Architectural Review
and Historic Preservation Board
Agenda Report

File: AR 19-07

RE: Architectural Review 19-07 (Arco AM/PM) - Southeast corner of the intersection at
Bruce Road at Highway 32, APN 002-180-084

DRAWING TITLE:
SITE LIGHTING PLAN

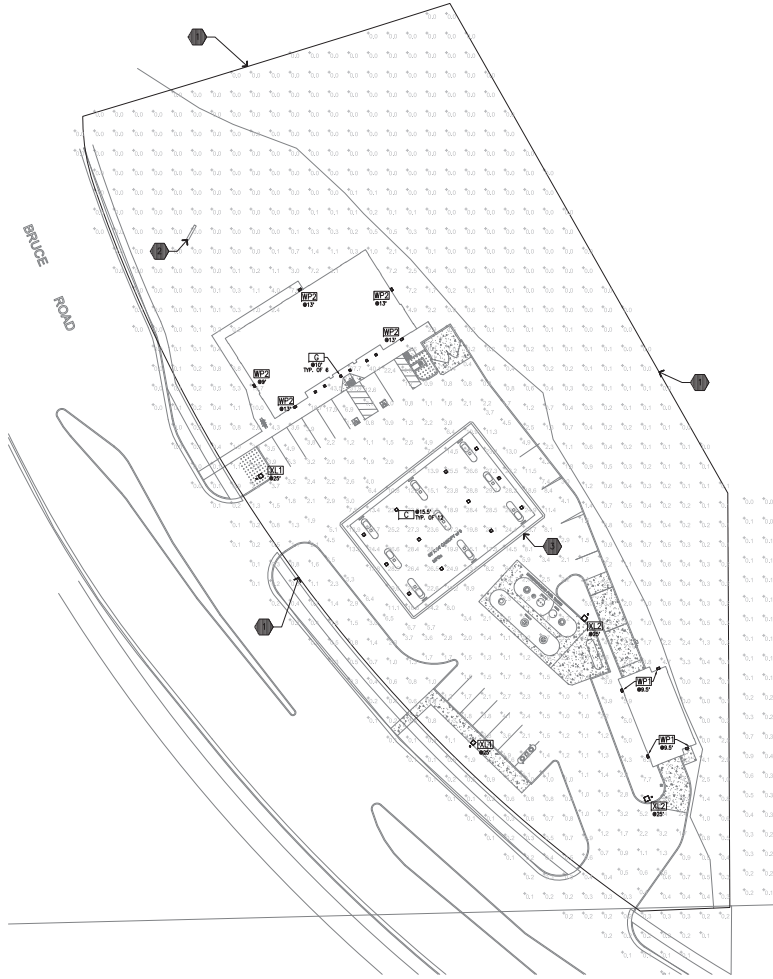
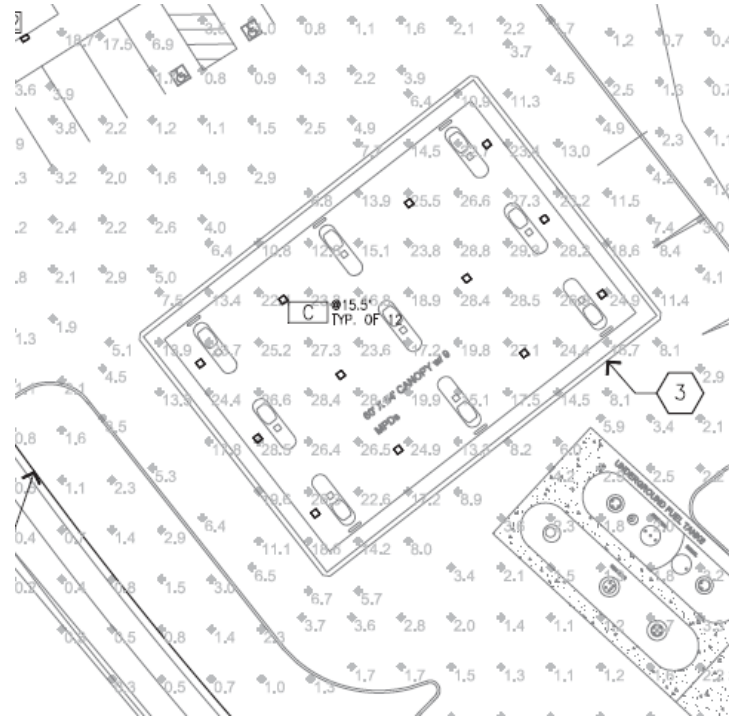
New light sources would be introduced to the site as part of the proposed project, including building-mounted light fixtures on the proposed convenience store and car wash facility, and 25-foot-tall ground-mounted light poles within the vehicle parking areas. The fueling station canopy would feature extensive lighting, including under-canopy surface-mount fixtures, internally illuminated canopy signs and a blue LED band wrapping the canopy. A photometric plan provided by the applicant indicates that light sources measured beneath the fueling canopy would reach up 28 foot-candles, reducing to below one foot-candle at the public right-of-way (see **Attachment D** Photometrics Plan and **Attachment E**, Light Fixture Specifications). CMC 19.60.050 (Exterior Lighting) does not provide explicit foot-candle parameters for development but requires that exterior lighting be recessed and directed downward so that direct glare and reflections are confined within the boundaries of the site. To avoid excess light and glare impacts to adjacent properties, and to reduce visual impacts seen from traffic ascending into Chico westbound on Highway 32, conditions of approval are recommended that would limit parking lot light poles to 18 feet tall (see Condition of Approval #3) and limit the blue LED fueling canopy band to only two of the four sides (see Condition of Approval #4).

LANDSCAPE PLAN

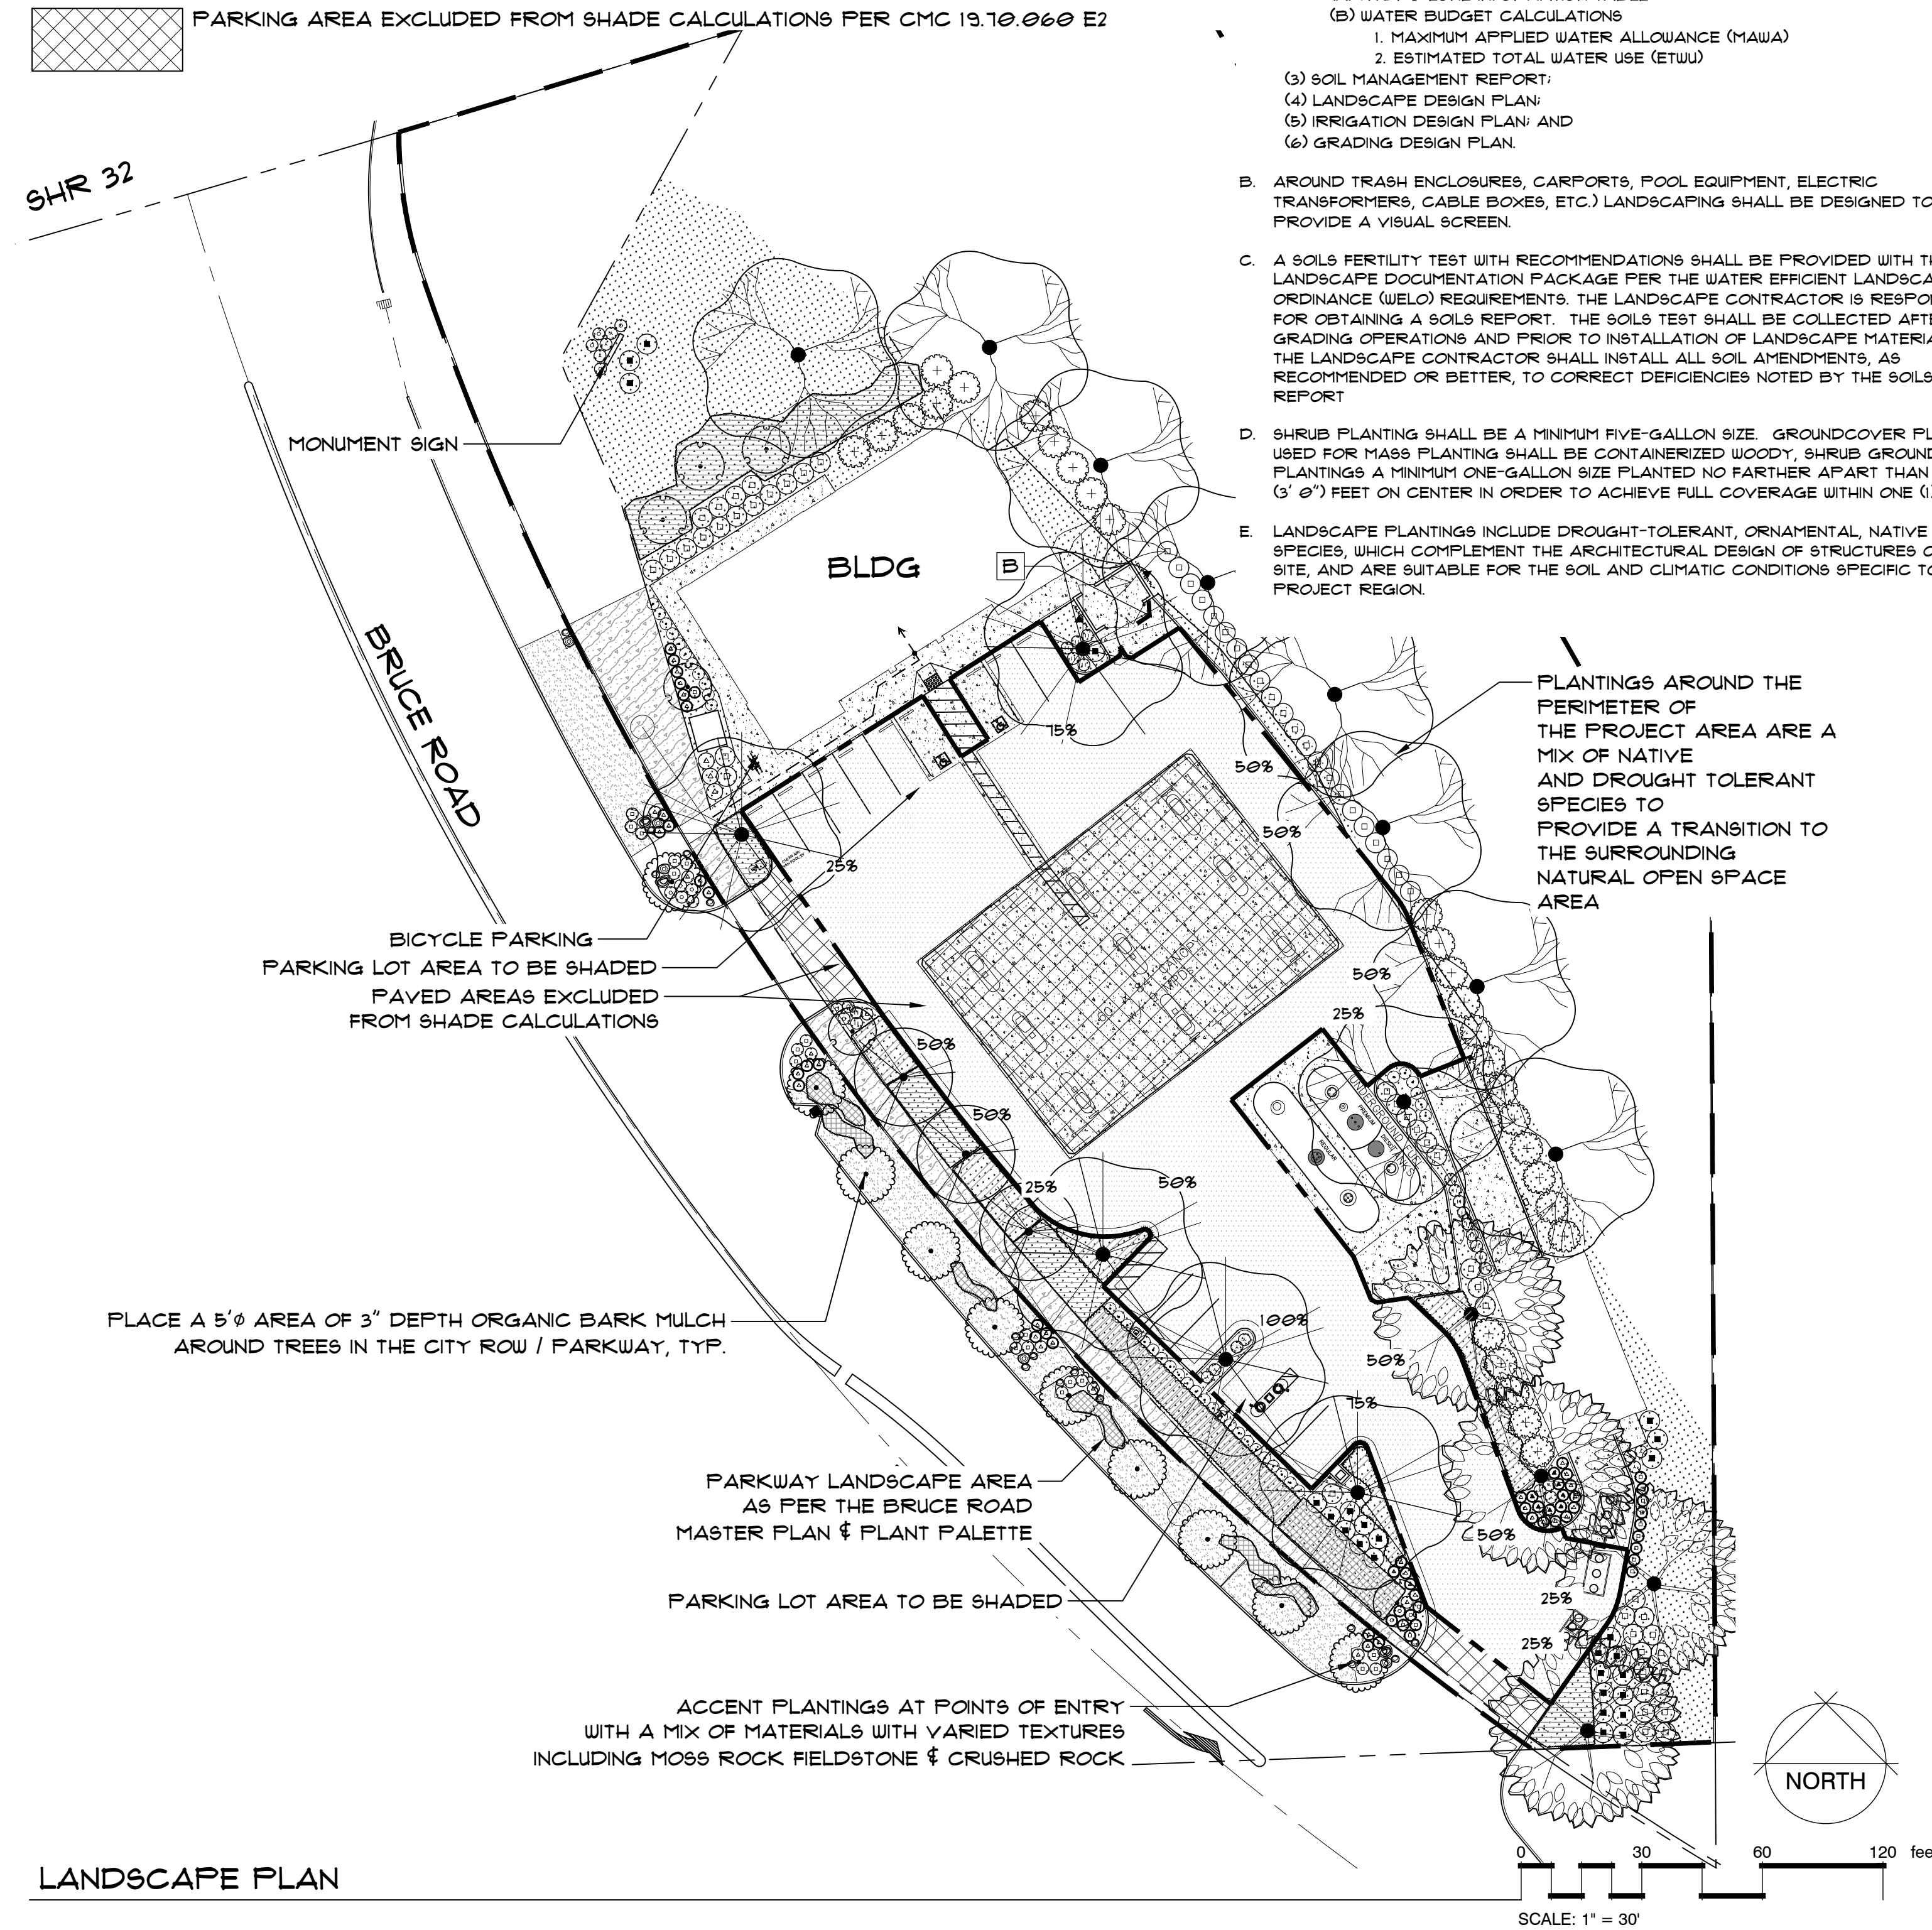
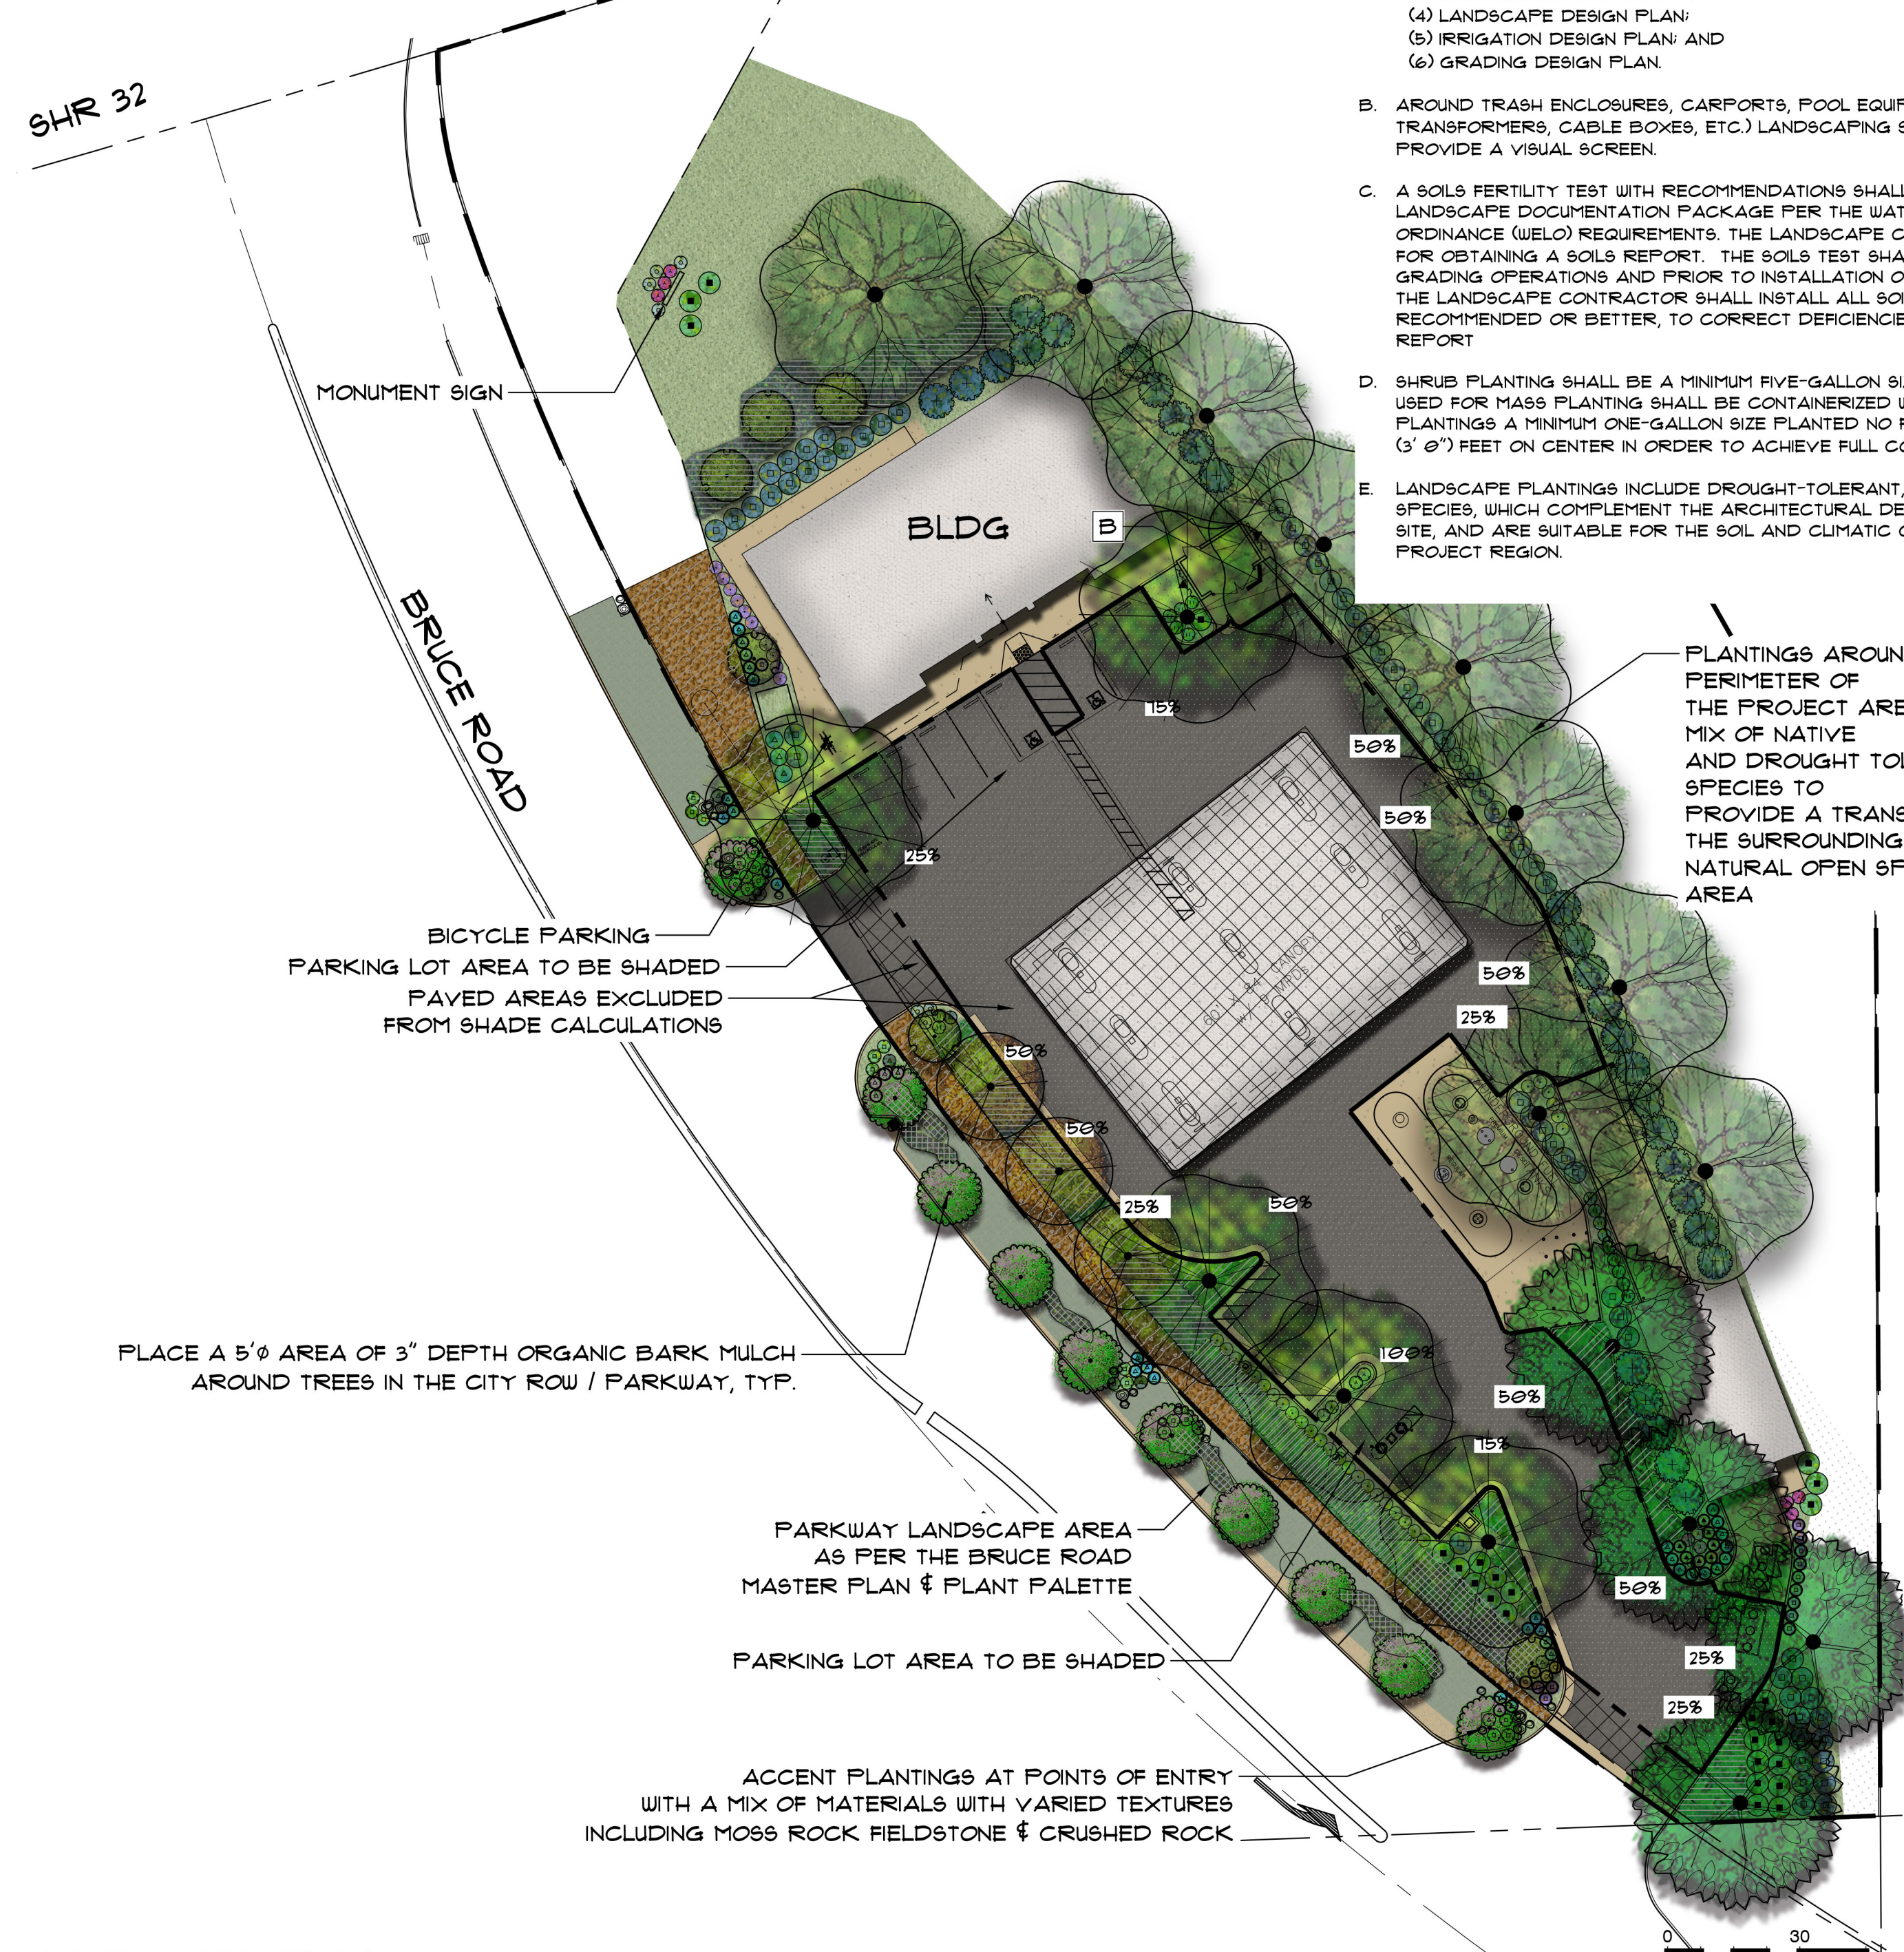
New landscaping is proposed throughout the project site with particular attention to the Bruce Road frontage (see **Attachment F**, Landscape Plan). Plant species are of low to moderate water demand and are largely species that are native to the area. The Bruce Road frontage would feature layers of planting materials, including ground-cover, low shrubs and decorative trees. Accent plantings would be located at points of entry on Bruce Road and would include a variety of material types, such as rocks, ground cover and flowers. Perimeter plantings on the easterly site boundary would include drought tolerant native species, such as Valley Oak trees, allowing new landscaping to transition to the surrounding natural open space. A total of 16 new trees would provide parking lot shade, which is estimated to reach 54-percent at full tree maturity. Shade trees would include species such as Chinese pistache, autumn blaze maple and California interior oak. An additional planter would be located interior to the site, adjacent to the drive-through car wash facility, and would provide screening of the drive-through queuing line from the public right-of-way.

Two trees would be removed as part of the project, including several oak trees. Such tree removal is subject to the City's Tree Preservation Measures (CMC 16.66) requiring on-site tree replacement or payment of in-lieu fees.

5. The final landscape plan shall depict creeping vines at the base of all lattice structures adjacent to the convenience store building and include treatment for undeveloped areas of the site outside of the Creekside setback (areas identified for future right-of-way dedication).
